Orient Allure Lingerie Ltd. & LZ Textiles Ltd. (Extension Building)

10 October 2021

Buildings Information

7 Observation: Connecting Bridge

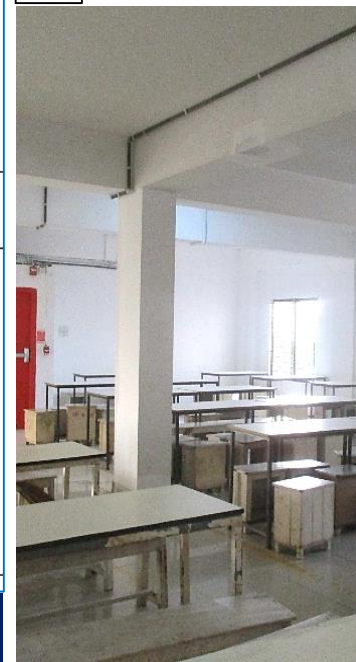
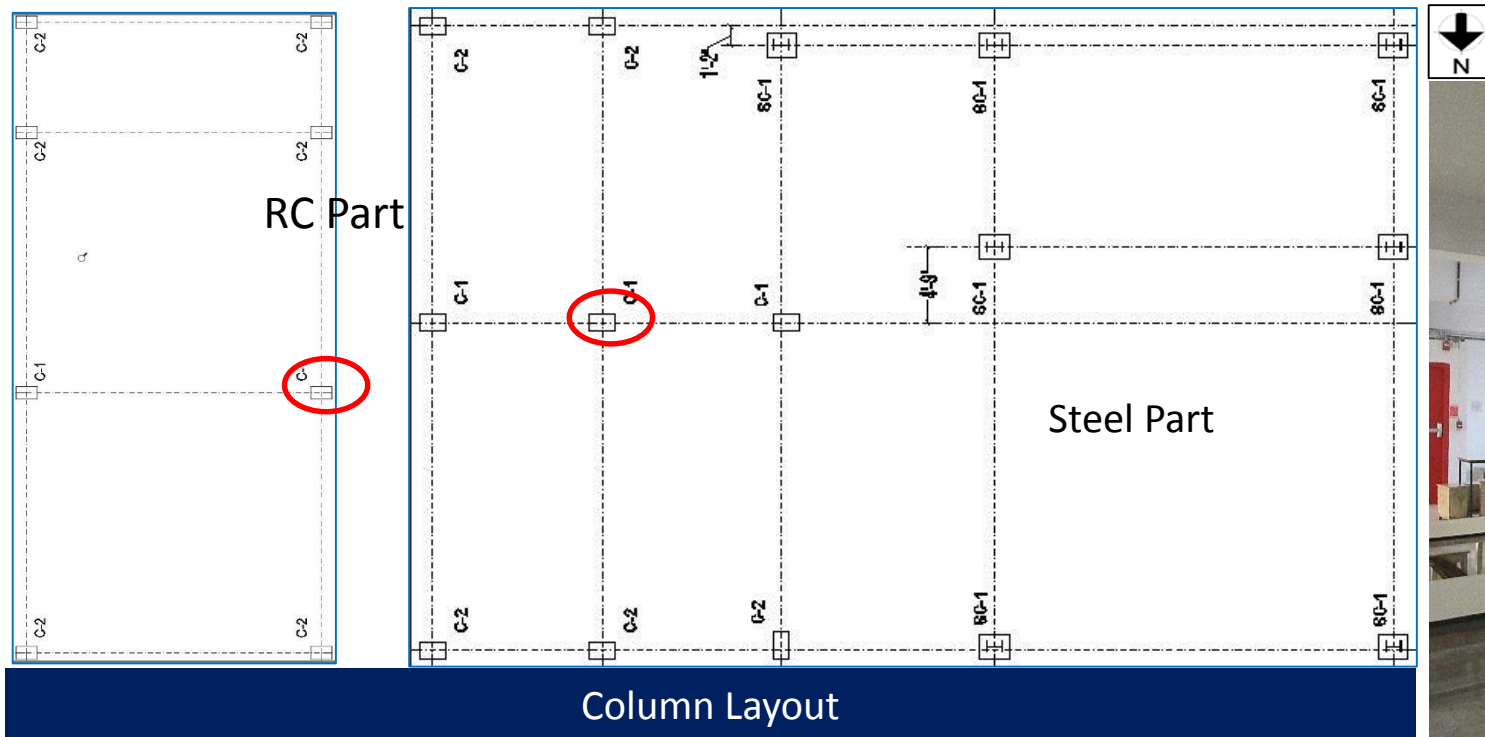
Discrepancies between drawings and as-built condition (Connecting Bridge)

Mismatch in rafter size at top

Welded connection

Connecting bridge

Rafter size was found 50 mm less than the provided drawing in connection bridge. Also, all the connections with columns were found welded whereas in drawing, all joints were showed bolt connections. Factory engineer is required to revise the drawing as per onsite condition.

Observation : Building-2 (Dining Building)

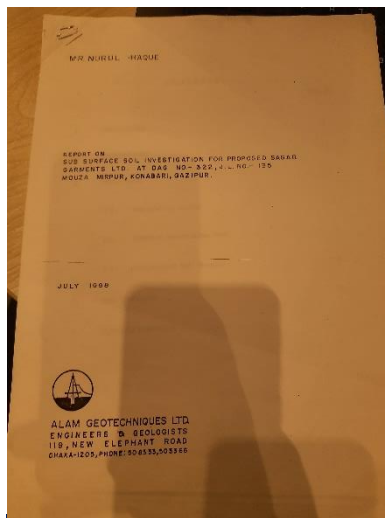
Column stress exceeds normal design limit

Cursory calculation indicate that the working stress of the marked columns exceed the normal design limit considering 3 kPa live load on typical floor, 1.5 KPa live load on roof and 16.37 MPa concrete strength. As part of Engineering Assessment (EA), factory engineer is required to verify the in-situ concrete strength, check the column capacity and suggest proper remedial actions accordingly.

Result of old geotechnical investigation report

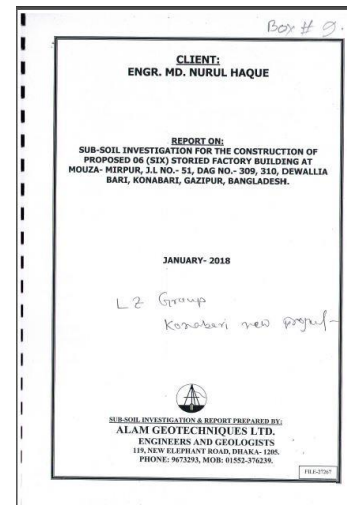
Geotechnical investigation report missing

An old geotechnical investigation (soil test) report was available dated (1998). As per bore hole layout of that investigation report, it doesn't cover the area of Building-2. A set of design report of Building-2 was available. In the provided design report, result of a new geotechnical investigation report was used which was not available during inspection. Factory engineer is required to collect the original geotechnical report of this building from concern lab/firm, otherwise conduct further geotechnical investigation in close vicinity of the building and check the foundation adequacy accordingly.
